**REPORT ON THE PEER REVIEW OF THE DATA EVALUATION AND
INTERPRETATION REPORT AND LOW RESOLUTION SEDIMENT
CORING REPORT FOR THE HUDSON RIVER PCBs SUPERFUND SITE**

—Final Report—

**U.S. Environmental Protection Agency, Region II
Emergency and Remedial Response Division
290 Broadway, 18th Floor
New York City, NY 10007-1866**

**Eastern Research Group, Inc.
110 Hartwell Avenue
Lexington, MA 02421**

Fig. D1-1. Water Column PCB Concentrations for Summer-Low Flow Conditions (Transect 6)

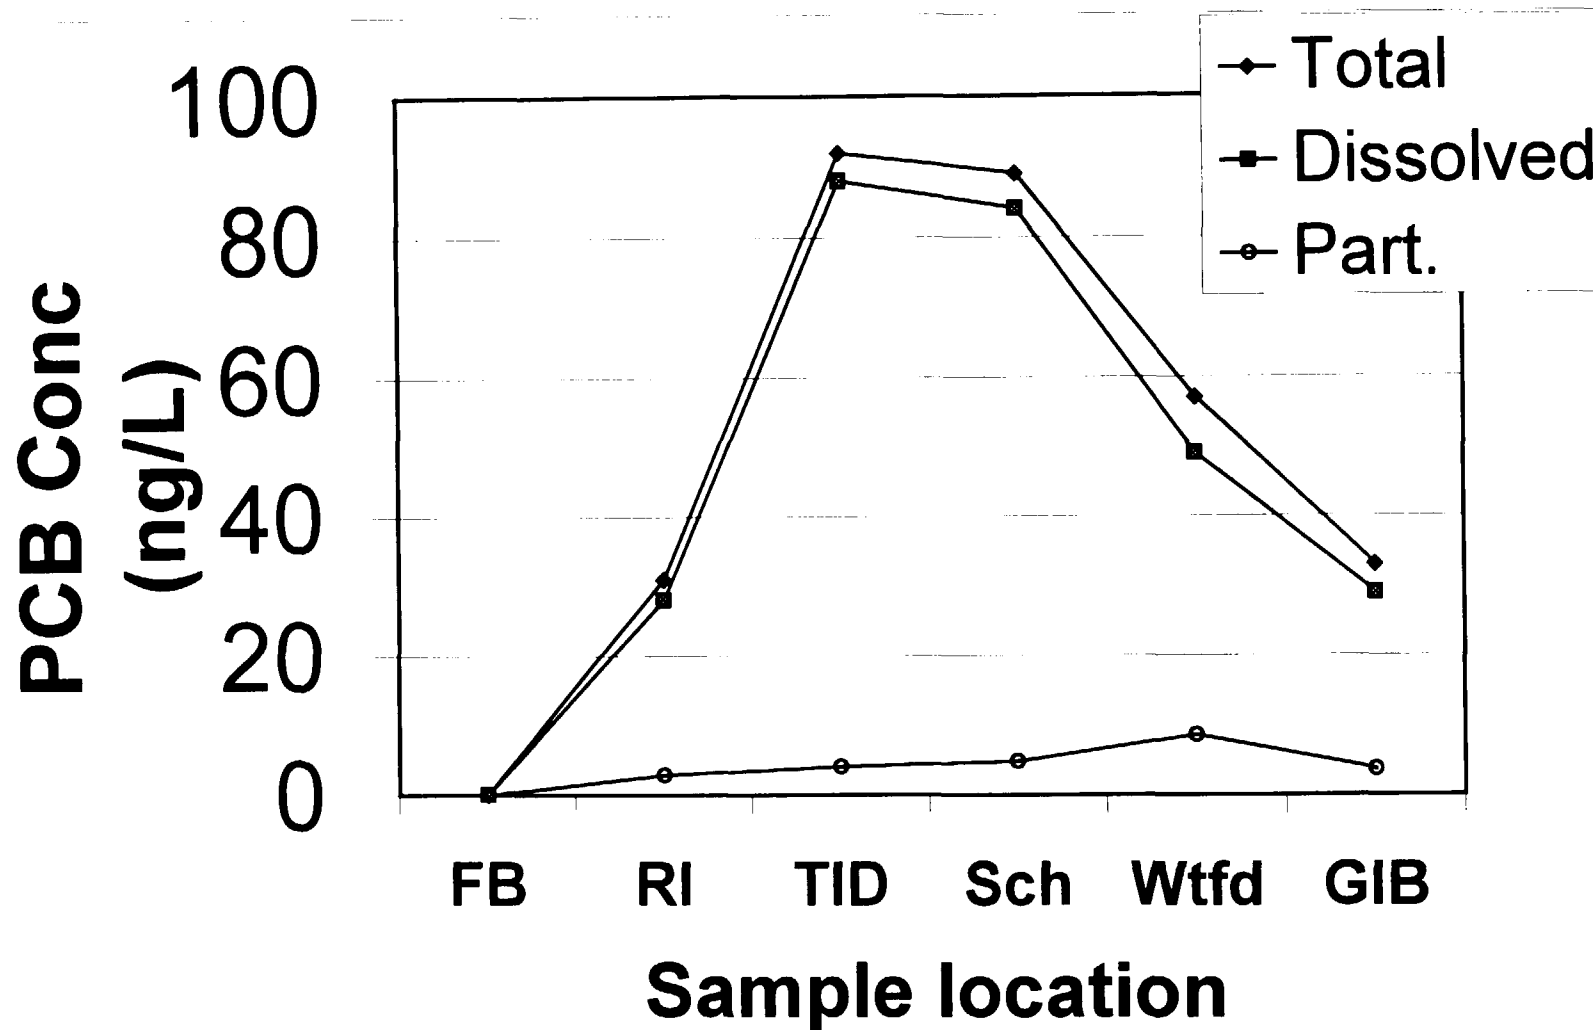
The only alternative explanation for these profiles is selective leaching of mono- and dichloro homologs from relatively immobile free product (oil droplets) upstream of the TI Pool. This would also require enhanced or accelerated "dispersion" of these homologs away from the source and a corresponding attenuation of trichloro- and higher homologs ("Tri+") in sediments upstream of the TI Pool. This scenario, however, would have been observed as a gradual shift in the homolog profile between the upstream Allen Mills source and the head of the TI Pool (Rogers Island). Since the sediments and water column samples collected at Rogers Island had a very different homolog pattern than that within the TI Pool (Figs. C-2 through C-4, and 3-38, 3-40, 3-43 and 3-47), this scenario is not a very likely one.

Fig. D2-1. Estimated Phase 2 log K's show increasing trend with $\log K_{ow}$ (Hawker and Connell 1988)

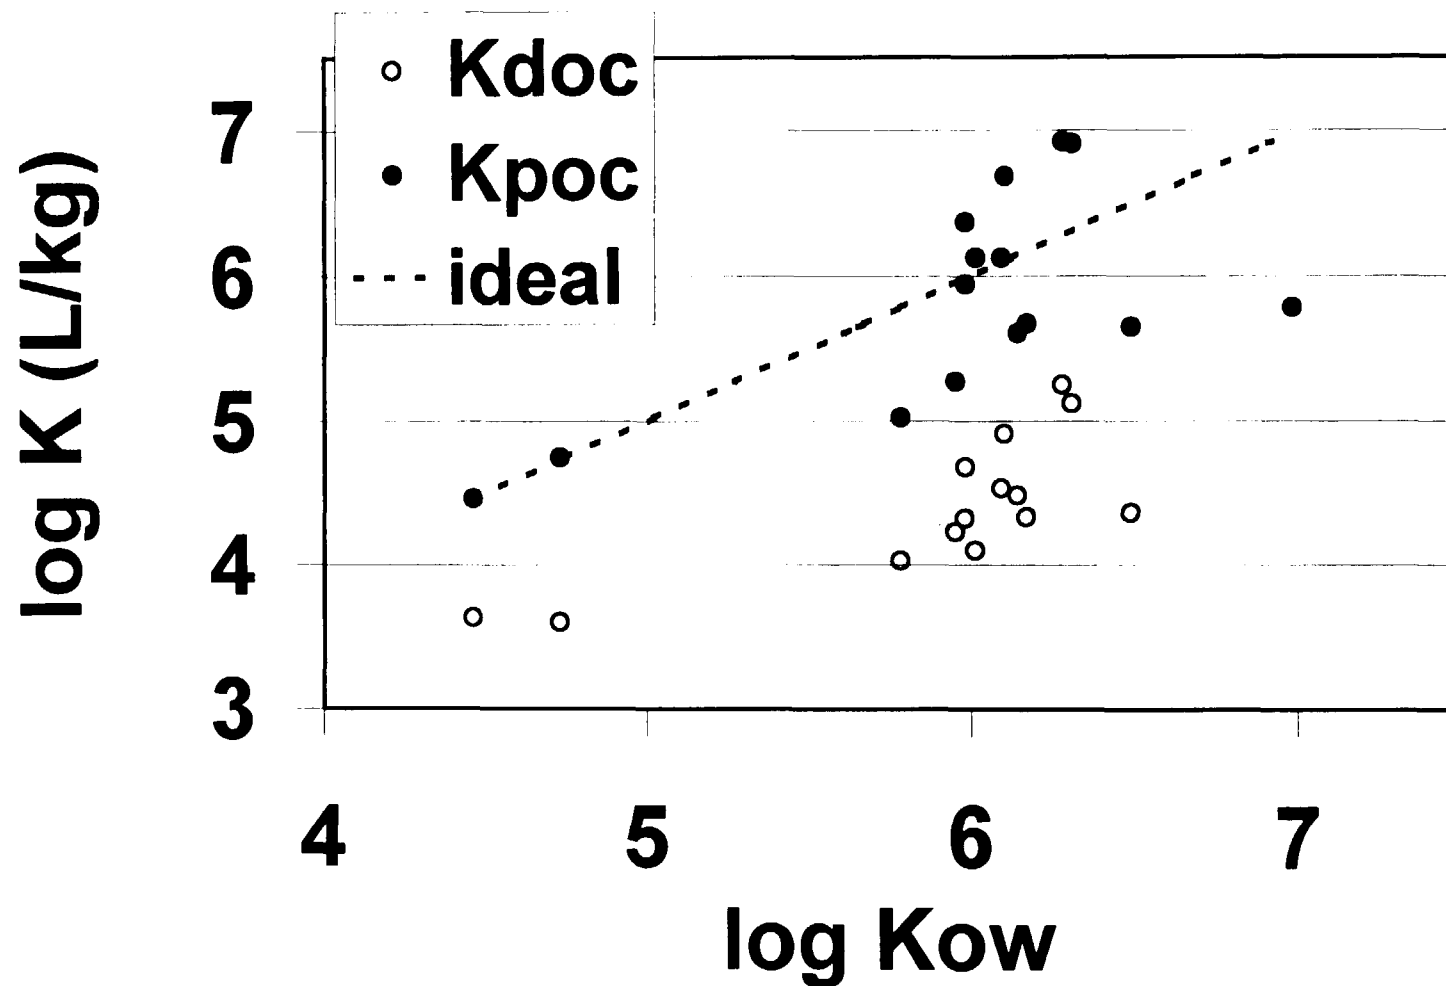
These estimates are presented for partitioning in the water column in Table 3-8 of the DEIR, and appear again as corrected values for bedded sediments (i.e. sediment and porewater distributions) in Table 2-2 of Book 3 of the DEIR Responsiveness Summary. In Table 2-2, K values are given for coeluting congener combinations with $K_{POC} > K_{DOC}$ without exception. My own analysis of the data show that log K's are positively correlated with log K_{ow} ($p < 0.01$; see Fig. D2-1 and Table D2-1 below). For New Bedford Harbor sediments, positive K_{POC} - K_{ow} associations were also noted by Burgess et al. (1996) and Brownawell and Farrington (1986). However, in Table 3-8, one curious exception is noted for BZ#8, where the estimated K_{POC} (5.19) is less than K_{DOC} (5.43). No explanation is given for this unique trend reversal, other than the fact that footnote "c" in Table 3-8 indicates some sort of blank problem. It is not clear if the congener specific results in Table 3-8 will be used in the future. If they are, I suggest that values for BZ#8 be revisited. If the data for BZ#8 turn out to be of questionable quality, interpolation or regressions based on aqueous solubility or K_{ow} , should be considered to estimate K values for this congener. For any future predictions of K, a quick check of the trend with increasing chlorines (or log K_{ow}) can be performed as a quick sanity check of the model.

On a more general note, it is not clear why all the effort was made to model the effects of DOC, especially since it was noted in the original version of the DEIR that DOC was fairly constant at ~5 mg/L in the water column. If these data were accurate, then one can conclude that DOC in the water column would exert a relatively constant and predictable influence in terms of partitioning. A case can be made that DOC in porewater of fine-grained sediment, although higher, would be relatively constant as well. In fact, in the example given in the DEIR Responsiveness Summary, Book 3, DOC was estimated @ 34 mg/L, ~10 times higher than that measured/assumed in the water column. The high degree of uncertainty in modeling the effects of DOC make it more of a mental exercise and less of a practical tool for modeling. The danger also exists that "over-manipulation" of model parameters such as partitioning constants can be abused to better fit *in situ* values.

I would thus recommend simplifying the partitioning model back to a 2-phase model instead of a 3-phase model. In the 2-phase model, DOC would be included as a more-or-less constant influence in the apparent or operationally defined dissolved phase.

Fig. D3-1. Model of PCB loading and downstream transport.

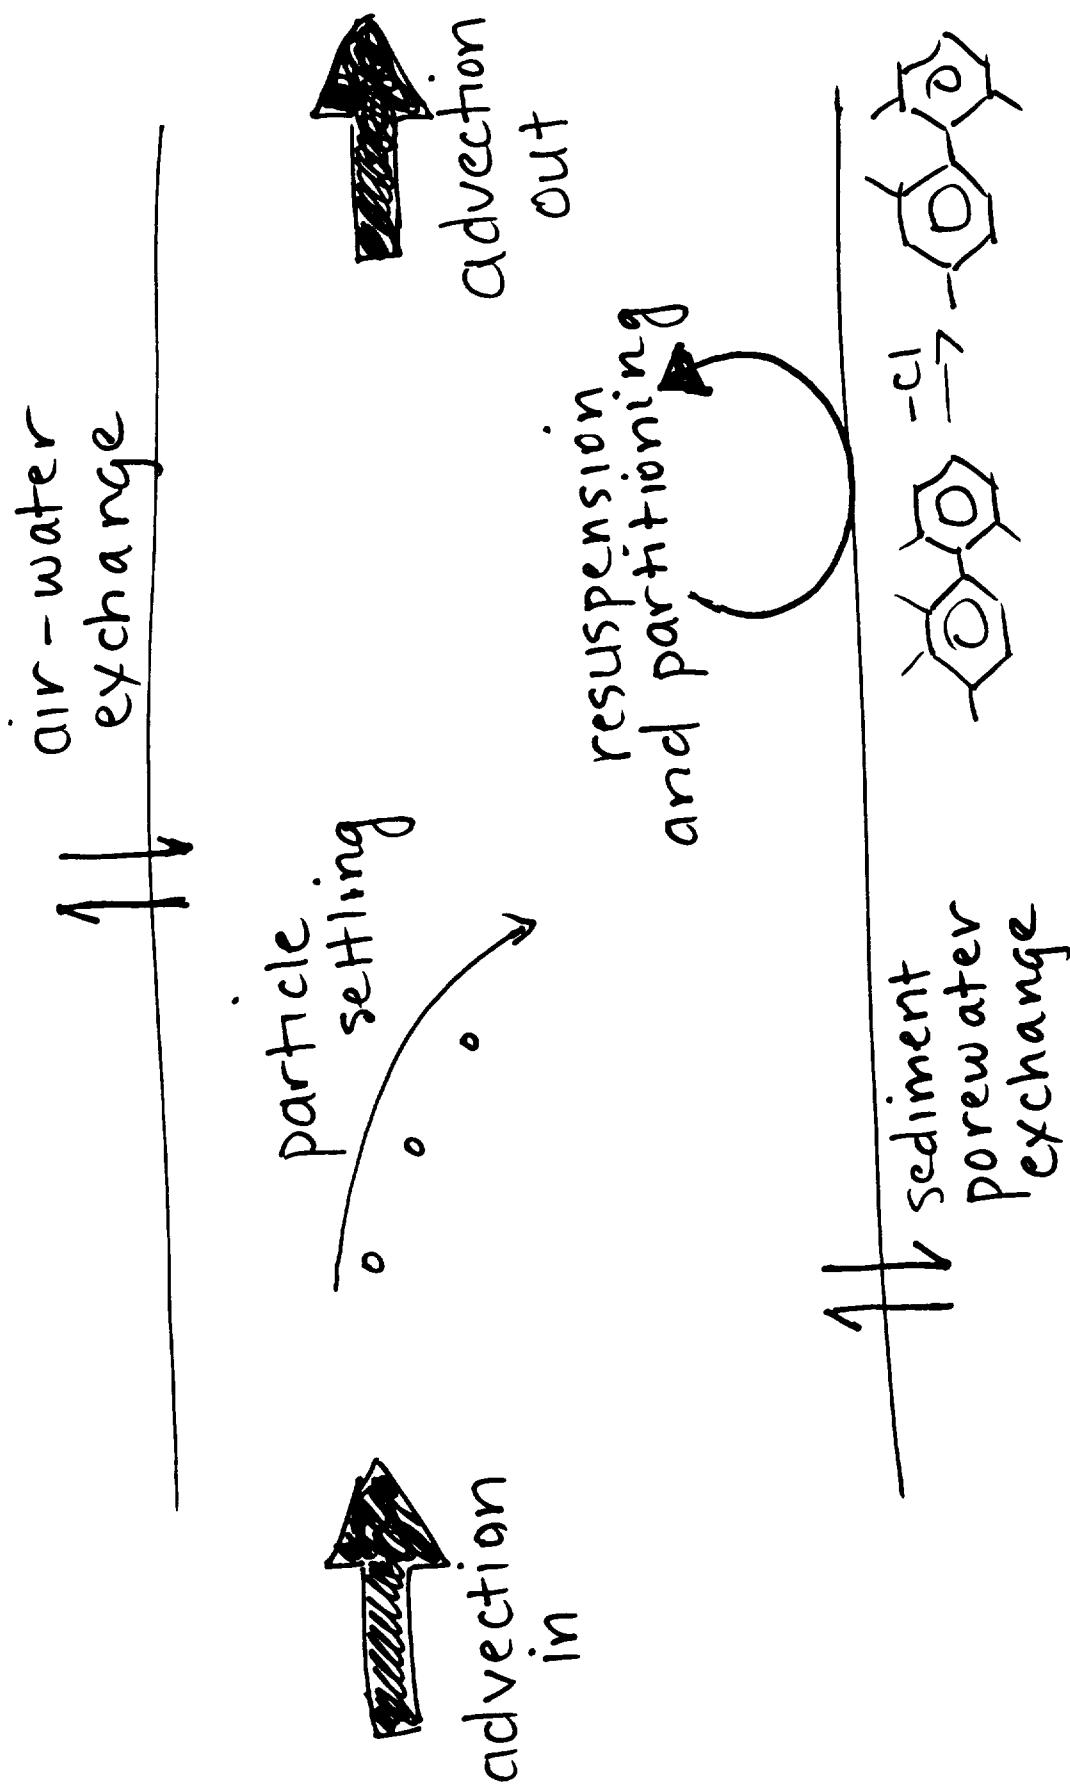
More limnological data (e.g. residence times; chlorophyll *a*, temperature gradients/stratification during summer low flow conditions) would likely improve our understanding of the processes at work in the TI Pool. For example, this stretch would seemingly act much more like a lake than upstream and/or narrower stretches of the Upper Hudson. As such, the processes acting on PCBs that are enhanced under lake-like conditions will be most important. The larger surface area to volume, increased residence time and quiescent flow regimes would likely result not only in greater fluxes of PCBs out of sediments and into the water column, but also into the air! Mass transport between phases is dependent both on the magnitude of the concentration gradient and surface area. The increased dissolved phase PCBs thus provide a larger driving force for transport out of the water column into the air. This flux would increase under summer, low-flow conditions when both air and water temperatures are at their annual maximum.

Fig. D3-2. Aqueous solubilities and Henry's Law constants (from Dunnivant et al. 1992)

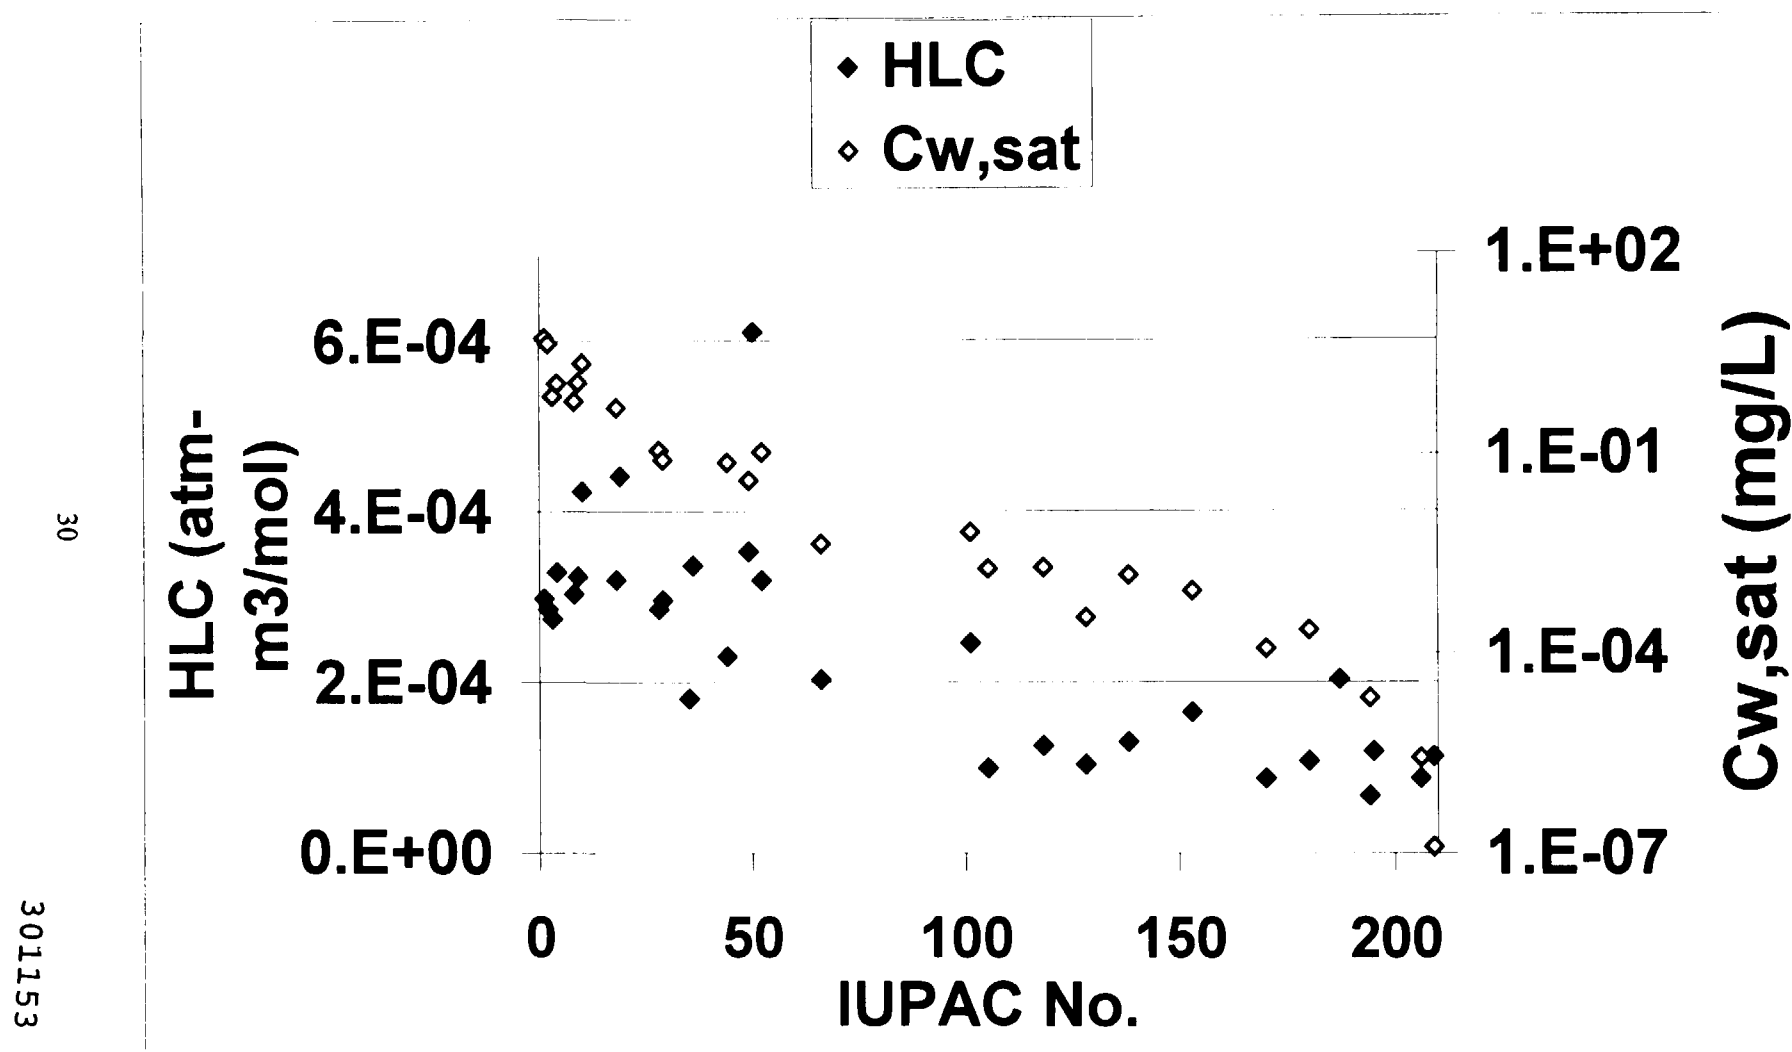
Because of their physicochemical properties including aqueous solubility and Henry's Law constants (see Fig. D3-2 below), mono- and diCBs will preferentially partition into the dissolved phase and into the atmosphere relative to heavier homologs. If air above the Hudson River is undersaturated, a constant flux of PCBs to the atmosphere can act to continually pull PCBs from the source (sediment) into the water column so that a concentration gradient is maintained.
